# LOCAL PLANNING PANEL AGENDA

27 November 2023

ITEM No.	SUBJECT	PAGE No.
2	<p><b>DEVELOPMENT APPLICATION DA-1386/2021</b></p> <p><b>DEMOLITION OF EXISTING STRUCTURES, THE CONSTRUCTION OF MULTI DWELLING HOUSING DEVELOPMENT CONSISTING OF 6 X 2 STOREY DWELLINGS, REMOVAL OF 5 TREES, AND ASSOCIATED WORKS.</b></p> <p><b>LOT 31 DP 27242 &amp; LOT 77 DP 27242</b></p> <p><b>58 MCGOWEN CRESCENT, LIVERPOOL &amp; 40 ATKINSON STREET, LIVERPOOL</b></p>	9 - 83

ITEM No.	SUBJECT	PAGE No.
3	<p><b>DEVELOPMENT APPLICATION DA-639/2021</b></p> <p><b>THE CONSTRUCTION OF TWO X 4-STOREY RESIDENTIAL FLAT BUILDINGS COMPRISING 39 RESIDENTIAL APARTMENTS, WITH ONE LEVEL OF BASEMENT CAR PARKING, AND ASSOCIATED LANDSCAPING AND SITE WORKS.</b></p> <p><b>LOT 231 DP 1287558</b></p> <p><b>LOT 231 CHANGSHA ROAD, EDMONDSON PARK</b></p>	84 - 164

Figure 17: Height Plane of the development showing extent of the building height encroachment

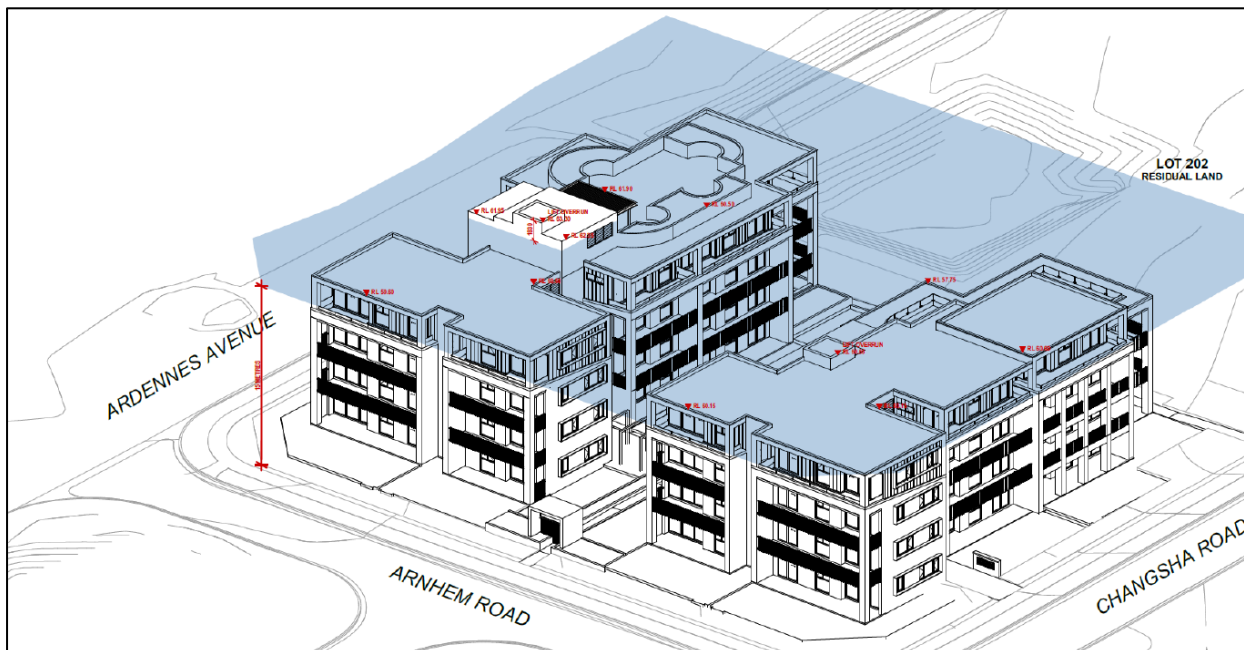
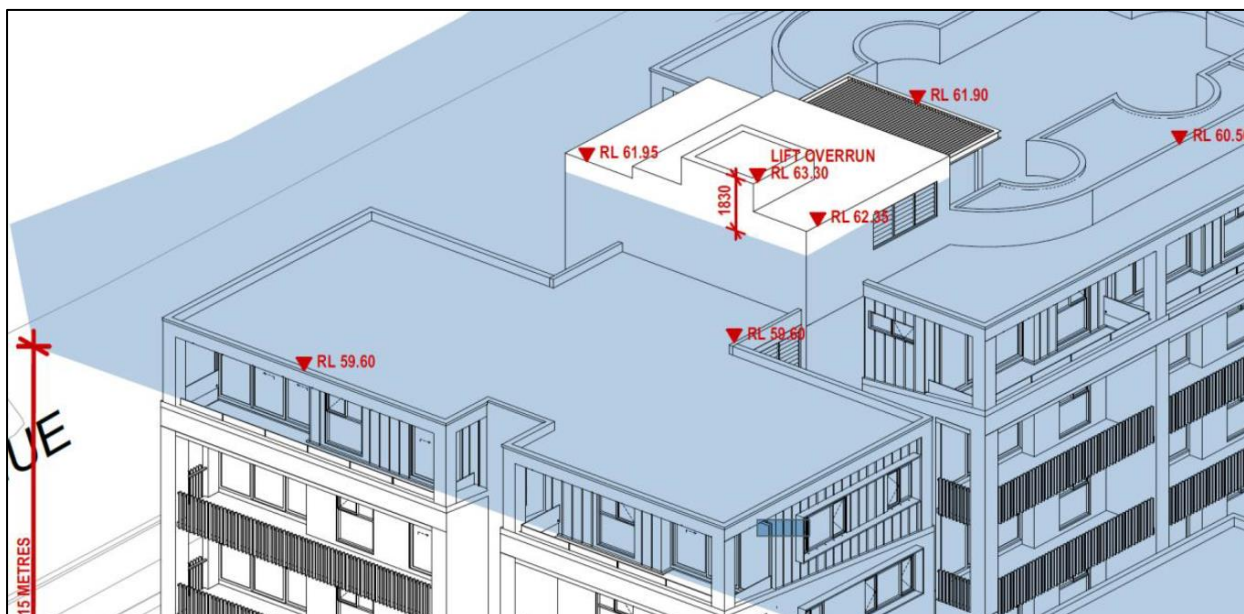
The subject proposal seeks a variation to the maximum height of buildings contained in LLEP 2008. The maximum height of buildings is to be 15m. The subject development is applying for an exceedance of building height to a maximum height of 16.83m, as measured to the lift overrun on the southern building. The variation is 1.83m, or 12.2% over the development standard. The extent of the variation can be found in the figures below.

Consequently, pursuant to Clause 4.6 of the LLEP 2008, the applicant has submitted a written request seeking a variation to the maximum height of buildings as prescribed by Clause 4.3.

Figure 19: Extract of Roof Plan for Southern Building

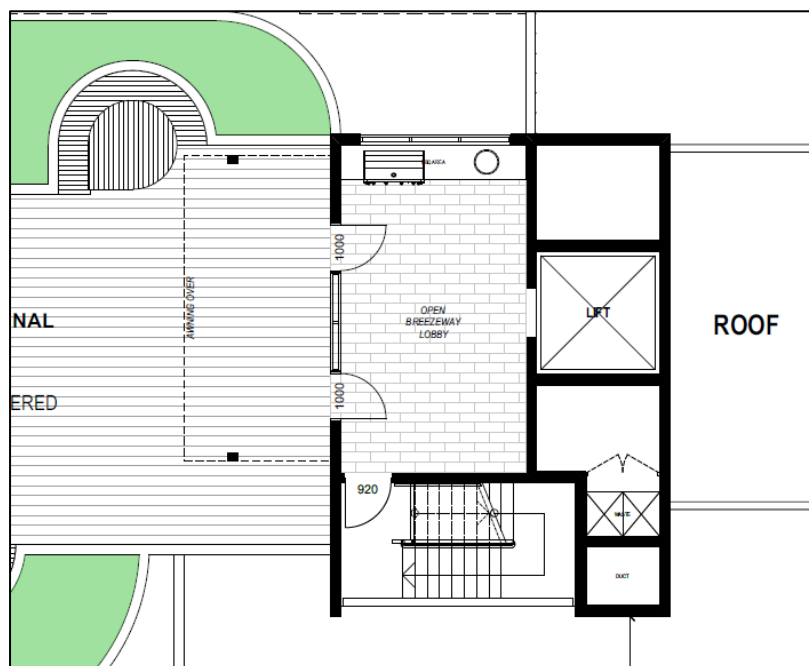
However, the provision of the communal open space on the roof has resulted in the proposal of additional gross floor area over and above the FSR development standard. The applicant has not included in their calculations the enclosed lobby adjacent to the lift which includes the BBQ. Refer to the extract below.

While the plans label the area as an ‘open breezeway lobby’, this space is almost entirely enclosed and fully roofed. The space does not achieve any criteria to be excluded from the calculation of GFA and contributes additional FSR. The application is not supported by a Clause 4.6 variation to justify the contravention and, per the discussion on Clause 4.4 earlier in this report, would not be supported due to insufficient environmental planning grounds. Accordingly, the height of buildings variation incorporates a non-compliant FSR which is not supported.
